**SUBDIVISION & PLANNED UNIT
DEVELOPMENT STAFF REPORT****Date: June 2, 2016**

<u>NAME</u>	Word of God Church
<u>SUBDIVISION NAME</u>	Word of God Church Subdivision
<u>LOCATION</u>	6455 & 6459 Overlook Road (South side of Overlook Road, at the South terminus of Godwin Lane).
<u>CITY COUNCIL DISTRICT</u>	District 7
<u>PRESENT ZONING</u>	R-1, Single Family District
<u>AREA OF PROPERTY</u>	3.3± Acre
<u>CONTEMPLATED USE</u>	Subdivision approval to create one legal lot of record; and Planned Unit Development to allow multiple buildings on a single building site with shared access and parking.
<u>TIME SCHEDULE FOR DEVELOPMENT</u>	Not Specified
<u>ENGINEERING COMMENTS</u>

PROPOSED SITE PLAN - PHASE 1

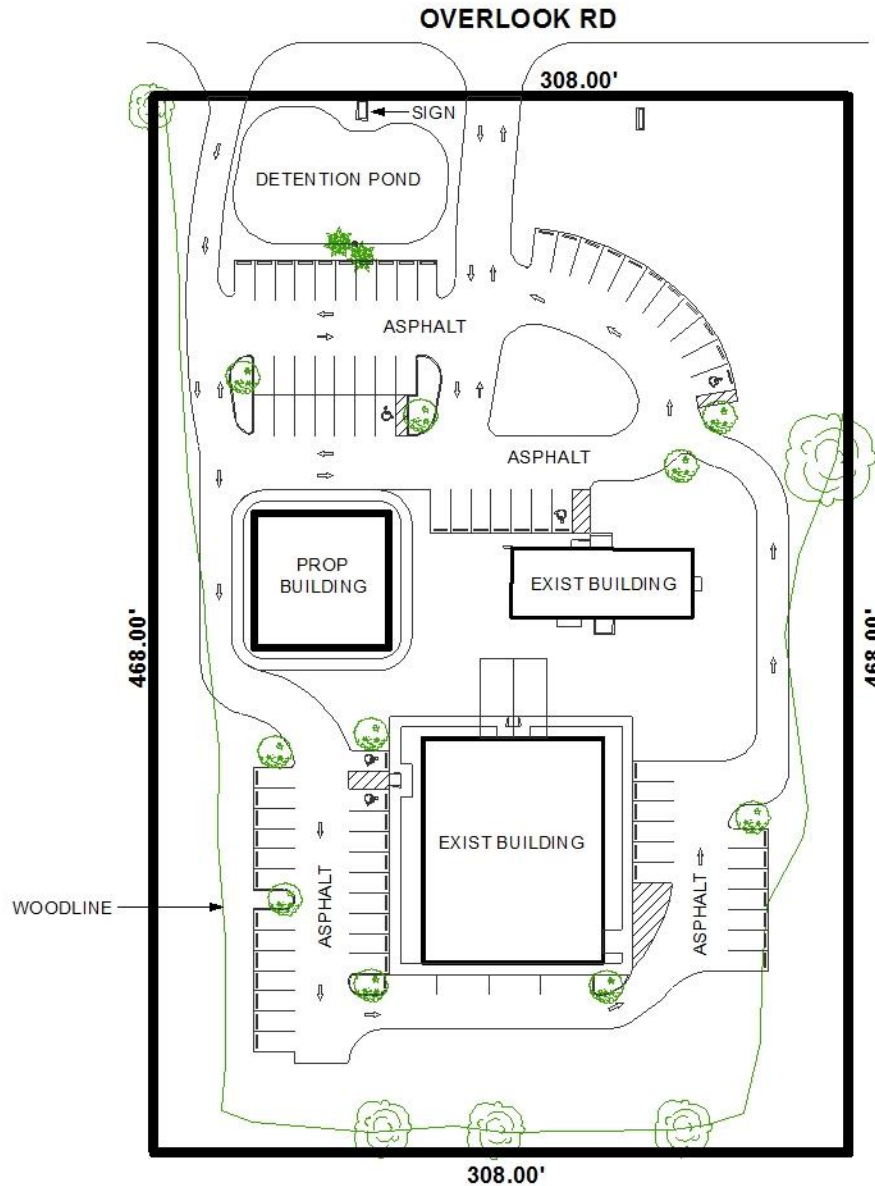
The proposed development appears to be compliant as it relates to site coverage; however, the site plan should be revised to illustrate compliant landscaping, tree, and parking calculations as required by Section 64-4.E of the Zoning Ordinance. Specifically, the landscape and tree calculations should also indicate the total site area, 12% of the total landscaped area required, 60% of the total frontage area required, the total landscaped area provided, as well as the frontage landscaped area provided.

The site plan illustrates that 86 parking spaces will be provided to accommodate the existing and proposed buildings on the subject property. The applicant states that there will be 297 seats in the church, requiring 74 parking spaces, but there is no mention of the proposed use for all buildings to be on the site. The applicant should revise the site plan to indicate the use of all proposed buildings on site so that staff can determine if it will comply with the Zoning Ordinance. Most of the parking spaces indicate wheel stops to prevent encroachment into landscaped areas, sidewalks, and buildings. It should be noted that the parking area must also provide lighting in compliance with Section 64-6.A.3 of the Zoning Ordinance at time of permitting.

The access widths, aisle widths, and parking space dimensions are all in compliance with the Zoning Ordinance, however, the one-way drives to the new structure may not comply with the 2012 International Fire Code minimum of 20 feet.

The 25' minimum building set back line is not depicted on the site plan, and should be illustrated on the revised site plan, adjusted for dedication.

The location and dimensions of the proposed HVAC mechanical equipment for the proposed structure are not illustrated on the site plan. The site plan should be revised to indicate the location, height and size of the HVAC mechanical equipment in compliance with Section 64-4.D.11 of the Zoning Ordinance.

The site plan does not indicate the method of garbage collection for the subject site. The site plan should be revised to illustrate that on site garbage collection will be served via a dumpster with a connection to sanitary sewer in accordance with Section 64-4.D.9 of the Zoning Ordinance, the placement of a note on the site plan indicating such, or a note should be indicated

on the site plan stating that garbage collection will be provided by curbside or private garbage collection services if a dumpster will not be provided.

A sidewalk is not depicted and labeled along the property's frontage on the site plan. If a sidewalk is not being proposed within the development of this site then a sidewalk waiver must be obtained, or a sidewalk must be provided and be clearly indicated on the site plan.

- 1) Submittal of a Planning Approval application by June 7th;
- 2) Provision of a written statement to indicate the timeline for construction;
- 3) Revision of the site plan to illustrate compliant landscaping, tree, and parking calculations as required by Section 64-4.E of the Zoning Ordinance;

- 4) Revision of the site plan to illustrate the 25' minimum building set back line;
- 5) Revision of the site plan to illustrate curbing or bumper stops for each parking space abutting landscaped area;

- 6) revision of the site plan to indicate the proposed use of each building on the site;
- 7) Revision of the site plan to indicate lighting within the parking area will be in compliance with Sections 64-6.A.3 and 64-6A.8. of the Zoning Ordinance.

- 8) Revision of the site plan to indicate the location, height and size of the HVAC mechanical equipment in compliance with Section 64-4.D.11 of the Zoning Ordinance;

- 9) Revision of the site plan to illustrate that on site garbage collection will be served via a dumpster with a connection to sanitary sewer, curbside, or private collection services in accordance with Section 64-4.D.9 of the Zoning Ordinance, or the placement of a note on the site plan indicating such;

- 10) Revision of the site plan to include a sidewalk or the application for a sidewalk waiver if a sidewalk will not be provided;
- 11) Placement of a note on the site plan stating that the PUD is limited to the existing curb cuts to Overlook Road, with the size, location and design to be approved by Traffic Engineering and conform to AASHTO standards.

- 16) revision of the site plan to reflect 2012 IFC access requirements.
